Project No. 111451

RE: Response to October 5, 2023 Masonville Stone, Permit No. M-1986-007, Technical Revision No. 3 (TR03), Adequacy Review No. 1

ATTACHMENT C
EXHIBIT E, FIGURE 1 AND FIGURE 2

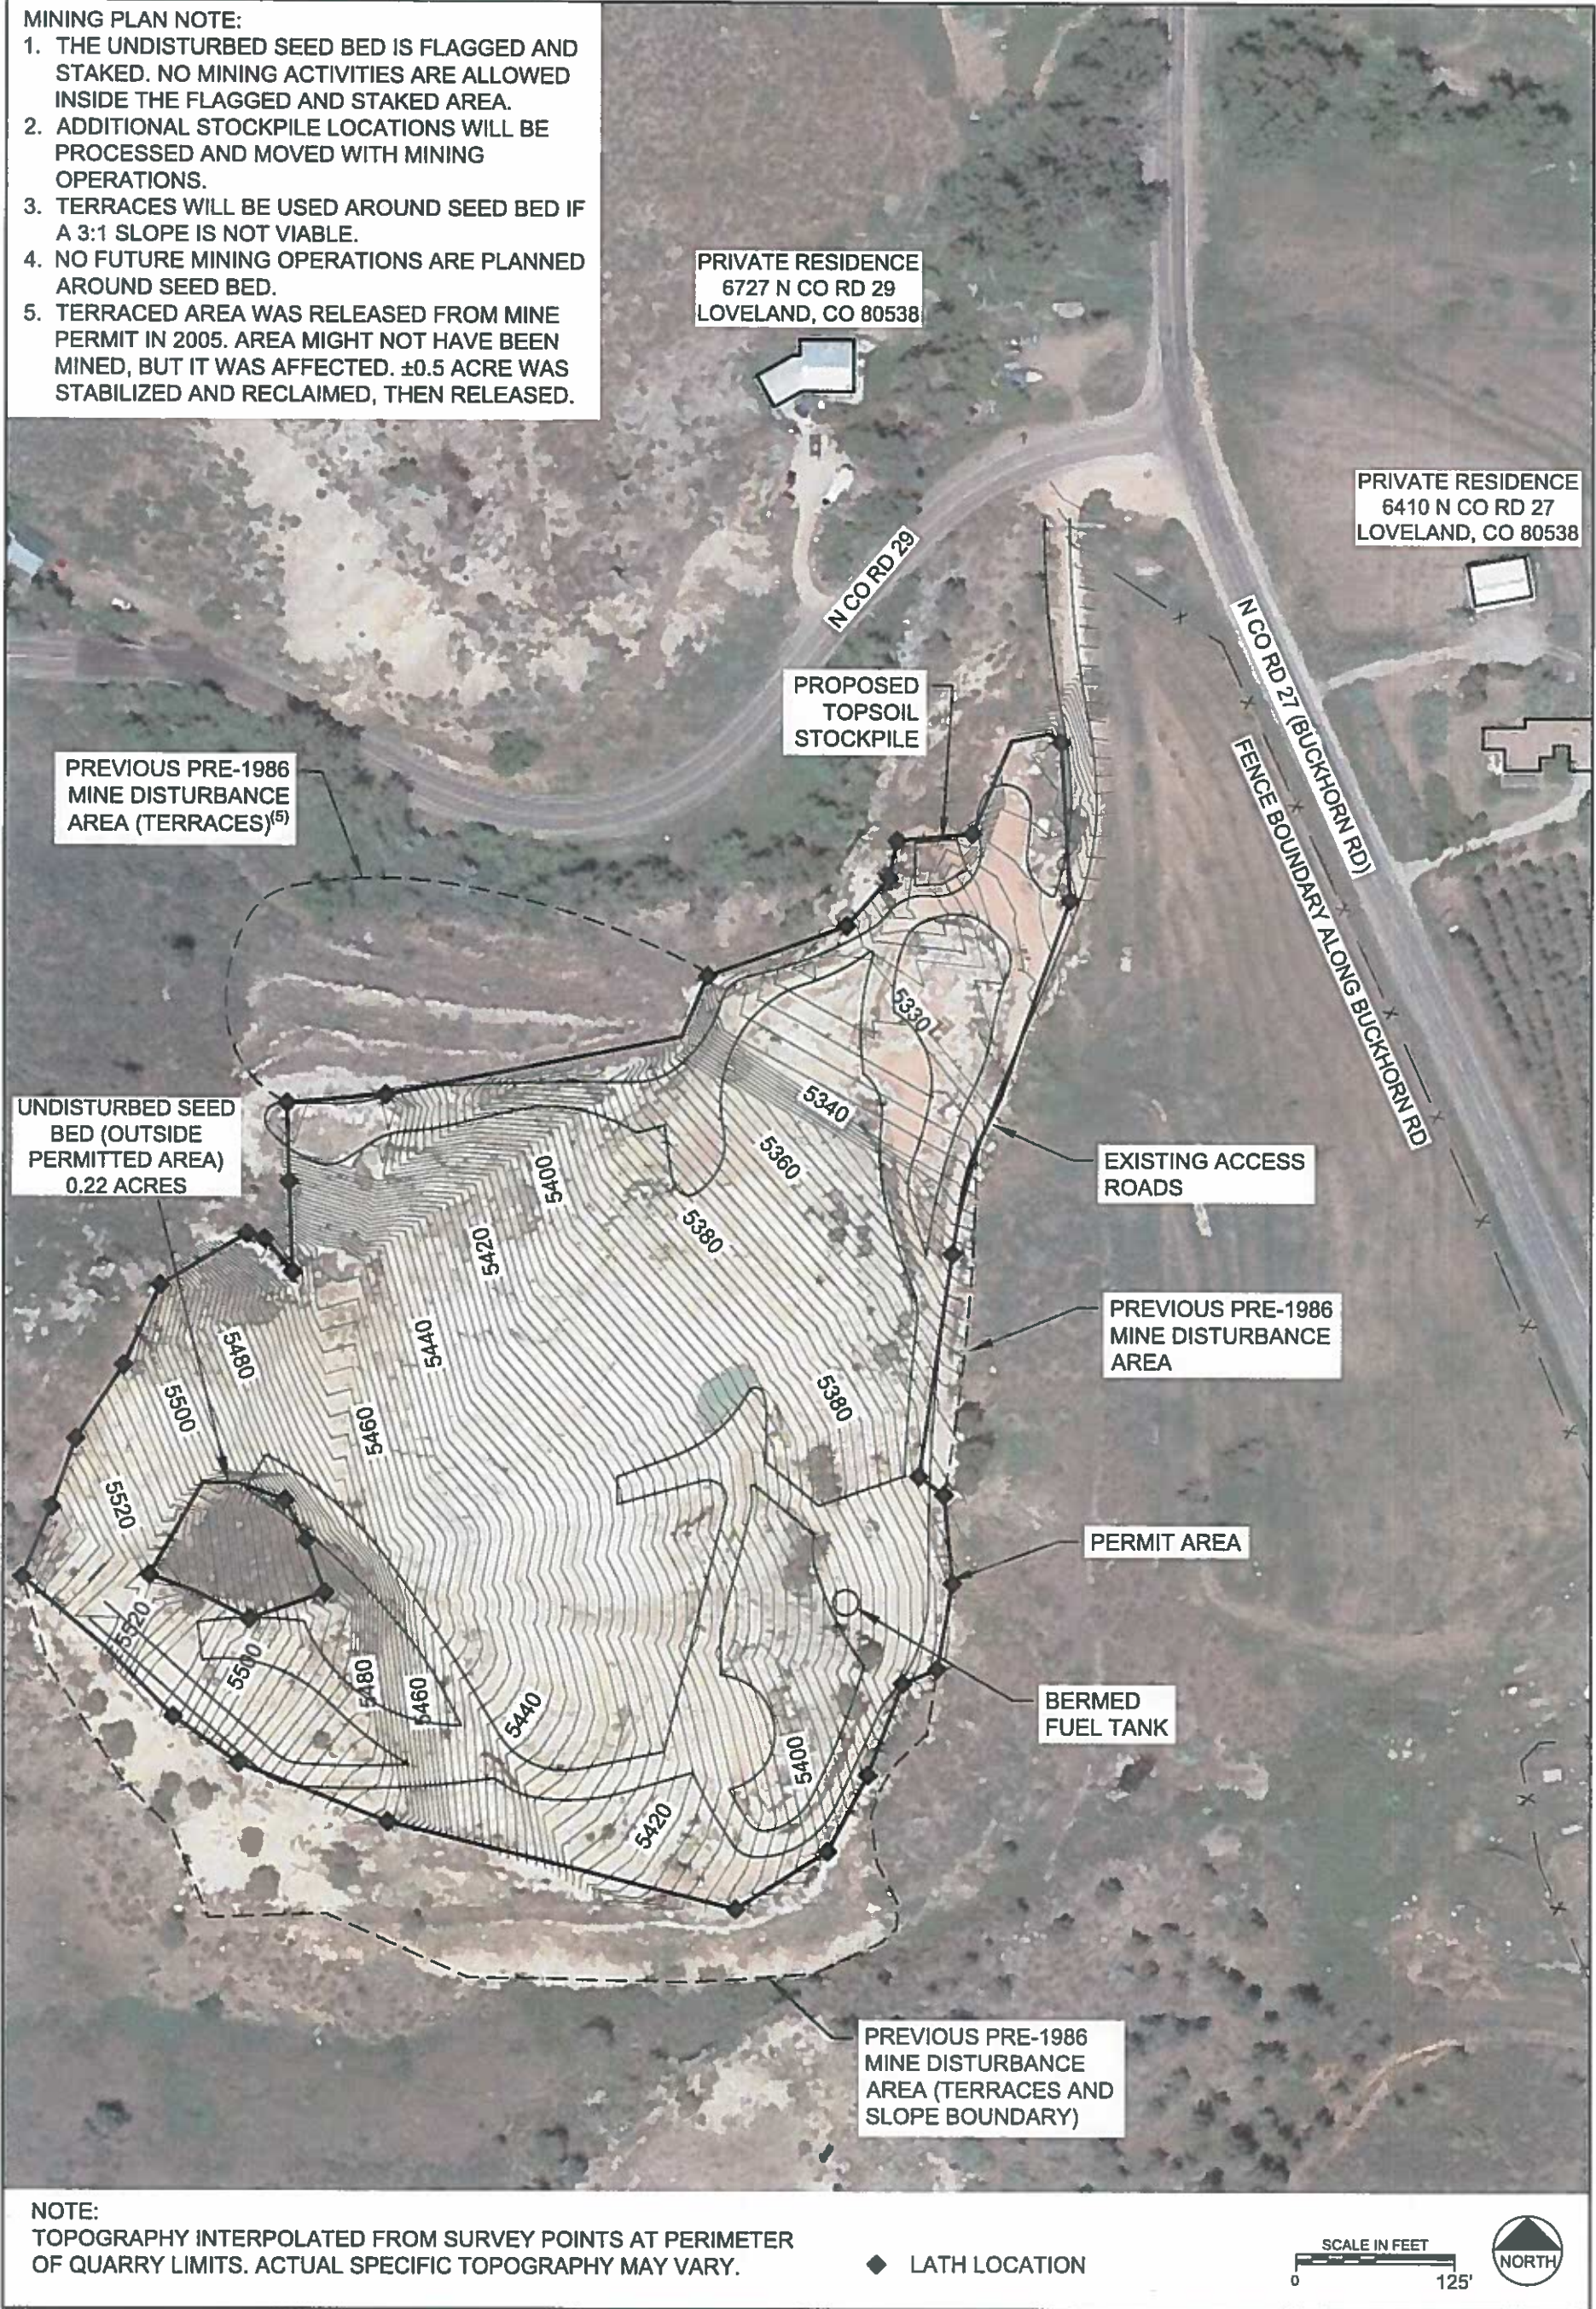
Mining Plan Map Comment 1. Please label the location and ownership of any significant, valuable, and permanent man-made structures within two hundred (200) feet of the affected area. This includes the two county roads, a fence running along Co Rd. 27, and any utilities or permanent structures within 200 feet of the permit area.

Mining Plan Map Comment 2. Please outline and label existing disturbance within and/or adjacent to the permit boundary (e.g., previously mined areas, roads or excavations resulting from utility construction). This includes any rock slabs, fencing, or rubble outside the boundary from current or historic mining

Mining Plan Map Comment 3. Please clearly outline and label the seed bed and note on the map that this is an undisturbed area not included in the permitted acres.

Reclamation Plan Map Comment 1. Please remove all mining plan details from the reclamation map, specifically “future excavation area” and “quarry pits” and “product stockpiles”, since these will not remain once reclamation is complete.

Reclamation Plan Map Comment 2. Show the gradient of all reclaimed slopes (horizontal: vertical) sufficient to describe the post mine topography on the map. Indicate if any terraces will be used to stabilize slopes.

Reclamation Plan Map Comment 3. Amendment 2, approved in November 2000, states that overburden will be replaced to depths anywhere from 2 to 15 feet as needed to fill in extraction sites. Please clearly label the average thickness of replaced overburden by reclamation area or phase on the map.

Reclamation Plan Map Comment 4. Amendment 2 states that topsoil will be replaced to a depth of 1-6”. The Division requires a minimum of 6” of topsoil for reclamation. Please show the thickness of replaced topsoil by reclamation area or phase on the map.

Reclamation Plan Map Comment 5. Please indicate on the map area where vegetation will not be established.

Reclamation Plan Map Comment 6. The reclamation map shows a network of roads in the mining area. Amendment 2 states the existing access road will remain after reclamation. Please clarify on the map which access road will remain and remove all other roads in the permit area.

***Response:** Locations and ownerships of manmade structures is identified in Exhibit E, Figure 1 Mining Plan Map.*

***Response:** Existing disturbances within and/or adjacent to the permit boundary have been outlined and labeled appropriately to match undisturbed locations and disturbance related to pre-1986 mining activities.*

***Response:** The seed bed has been outlined and labeled to illustrate it is not included in the permitted area. In addition, the seed bed is flagged is not accessed by any mining equipment or personnel.*

***Response:** All mining plan details have been removed from the reclamation map.*

***Response:** The gradient of reclaimed slopes will be maintained at 3:1 and terraces will be used to stabilize slopes in areas where terraces are already installed and in use. Terraces have been identified to be used northeast of the seed bed to address the current cutoff slopes that cannot be graded to a 3:1 slope. The areas north, west and east of the seed bed will be filled with overburden to meet the 3:1 slope.*

***Response:** The overburden will be placed at an average depth of approximately 8.5 feet. Due to changes in elevations, overburden can be as shallow as 2 feet and as deep as 15 feet.*

***Response:** To meet the divisions minimum requirement, topsoil will be replaced at a minimum of 6” across reclaimed areas.*

***Response:** Vegetation will be established in all reclaimed areas excluding access roads.*

Response: The reclamation map plan has been updated to outline access roads that will remain after reclamation.
